Sundry ID: 2884685

Type of Action: APD Change

Procedure Description: Devon Energy Production Co., L.P. (Devon) respectfully requests a variance for break test and offline cementing of the intermediate and production casing on the subject wells. Please see attached break test and offline cementing supporting documentation.

Procedure Description: Devon Energy Production Co., L.P. (Devon) respectfully requests to change the drilling updates on the subject wells (AFMSS ID: 10400103768 & 10400103776). Please see attached revised Drill plan, directional plan, and spec sheets.

Offline Procedure – Detailed

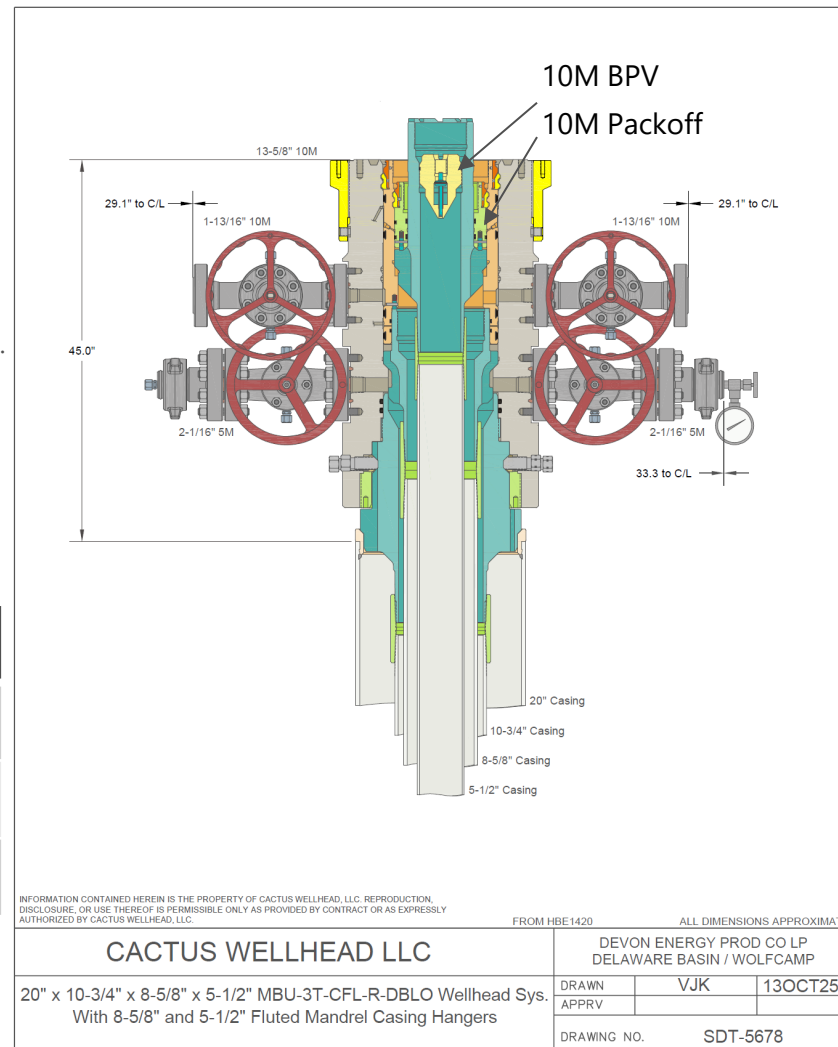
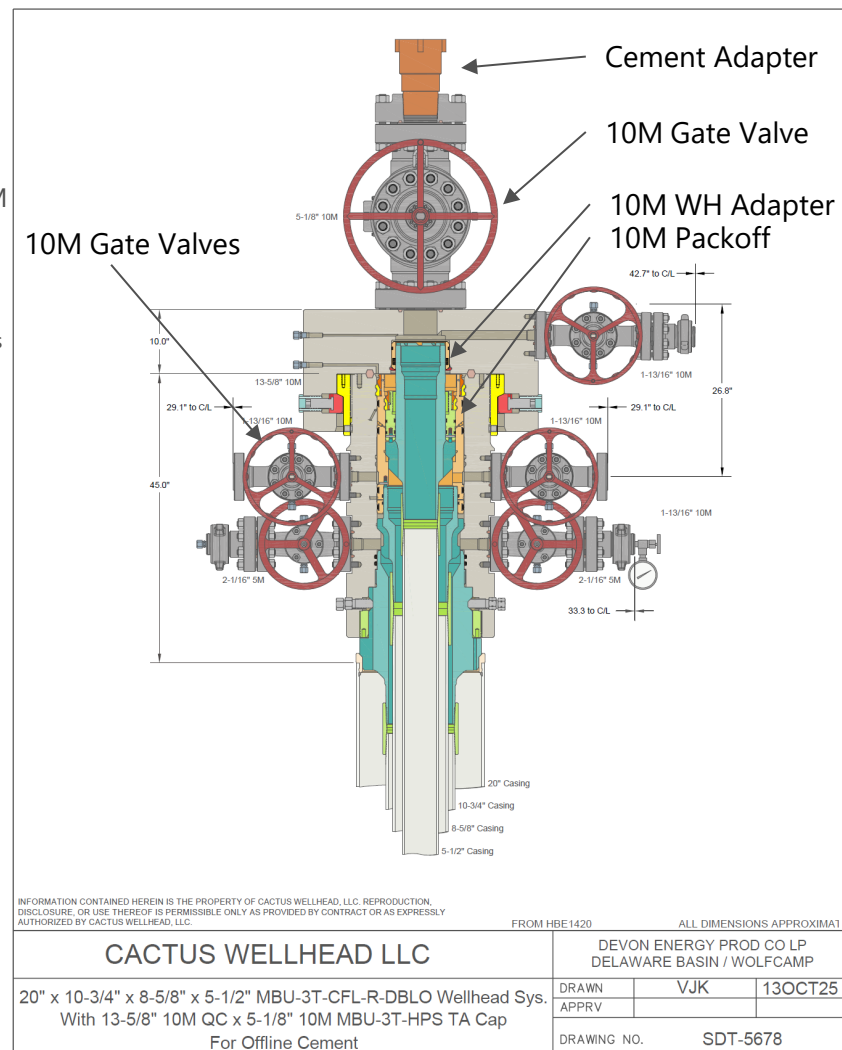
- Run casing and perform negative pressure test during casing run to verify integrity of float equipment's 10M backpressure valves.
- Review Devon's "Punch List" to determine if well is a viable candidate.

- Install 10M Gate Valve and Cactus WH adapter.
- Test connection between WH adapter seals, hanger neck, and ring gasket to 10,000psi.
- Open Frac Valve and remove BPV.

- RU cement head, cement iron, return lines and test same.
- Once all equipment is rigged up, barriers tested and ready to cement, notify BLM of intent to Cement Offline.

- **Devon's Proposed Production Offline Procedure (continued):**
- Perform offline cement job.
- If an influx is observed during the cement job:
 - The Day and Night Company Men will redirect returns from Cementing Manifold to the Rig's choke manifold and hold appropriate backpressure to circulate out influx.

- RD cement head and install BPV.
- Remove Gate Valve and WH adapter.
- Install TA Cap with pressure gauge and test same.
- ***Note*** - If the well is within the KPLA, and an uncemented annulus between the Production and Intermediate casing has been utilized; then cement shall be squeezed down both casing valves within 180 days of the well's completion and displaced with a treated fresh water to a TOC below the potash interval and marker bed number 126, with a minimum of 500' tie-back inside the Intermediate Casing as per R111Q.

Component Table:

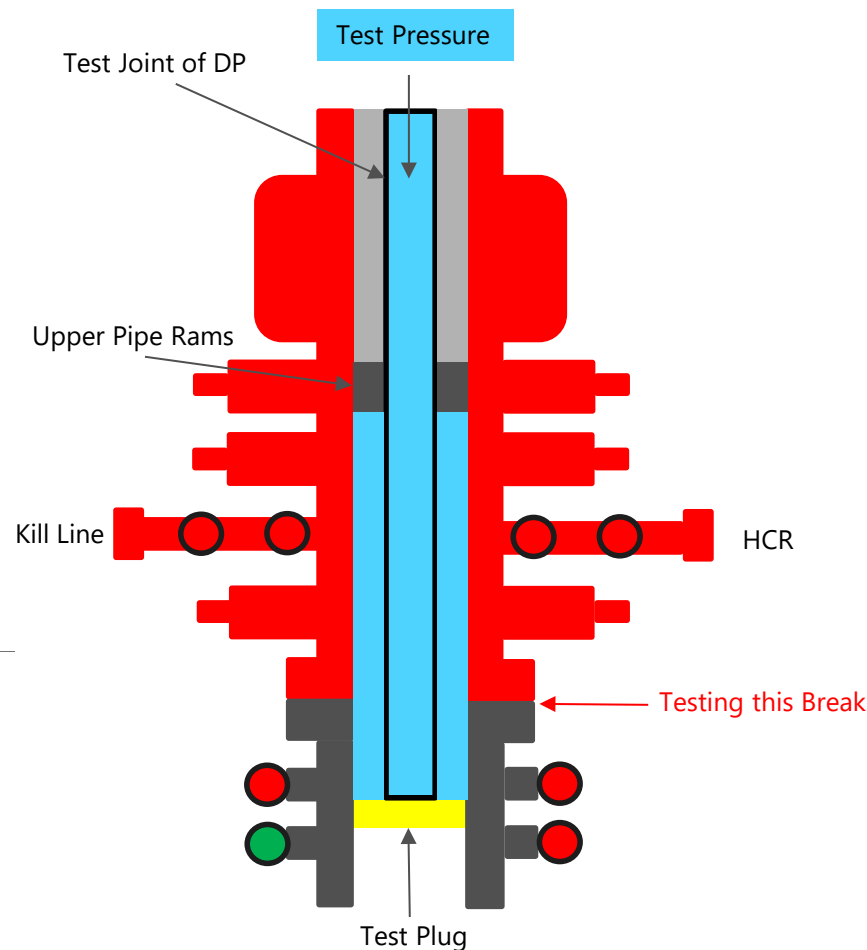
Devon requests offline BOPE testing for the following components: Upper Rams, Blind Rams, Kill Valves, Choke Valves, and Annular

Remaining well control equipment components will either be tested offline or online, per BLM approval

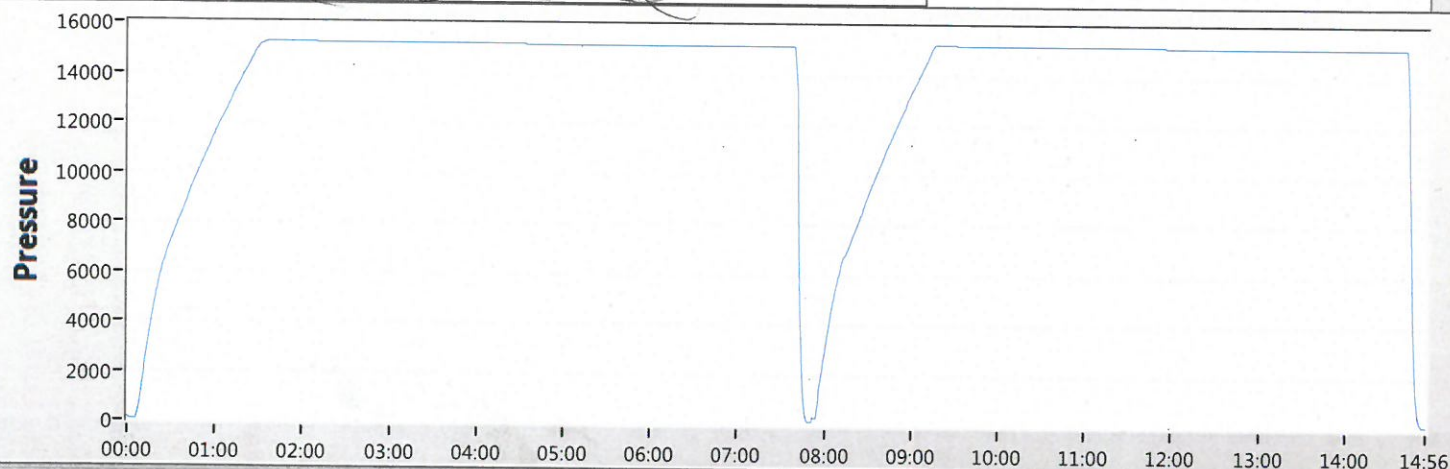
Devon requests Break testing as stated above for 5K tests, not including production hole

Annular Preventer will be tested to minimum of 70% RWP and higher than MASP during initial BOP test

Pressure testing is required for pressure-containing connections if the integrity of a pressure seal is broken during a break test

Full Tests required when entering production hole

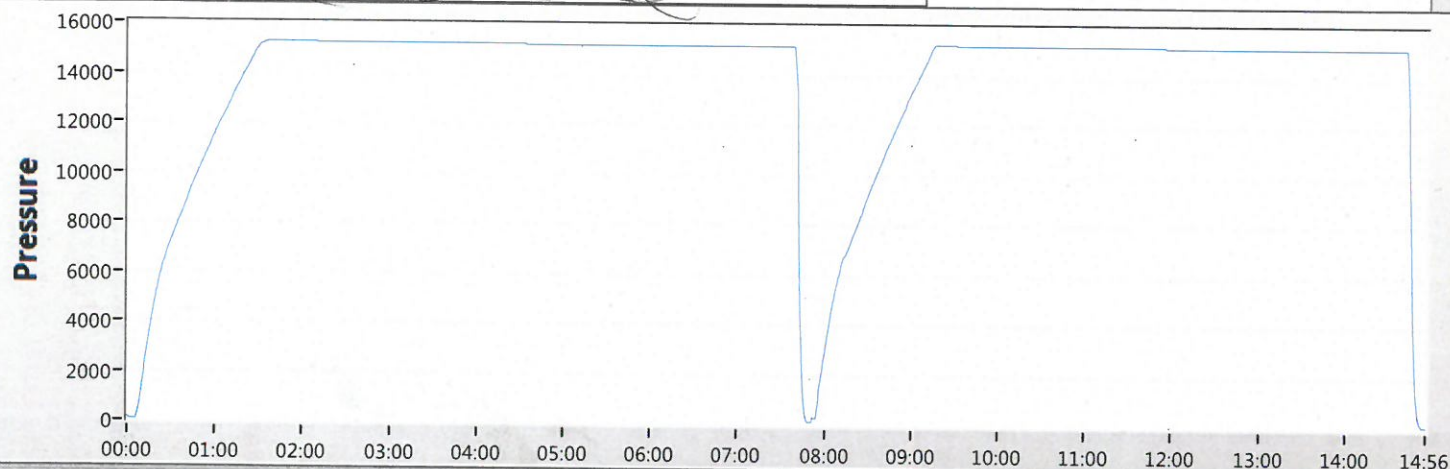
Devon requests Break testing as stated above for 5K tests, not including production hole

Annular Preventer will be tested to minimum of 70% RWP and higher than MASP during initial BOP test

Pressure testing is required for pressure-containing connections if the integrity of a pressure seal is broken during a break test

Full Tests required when entering production hole
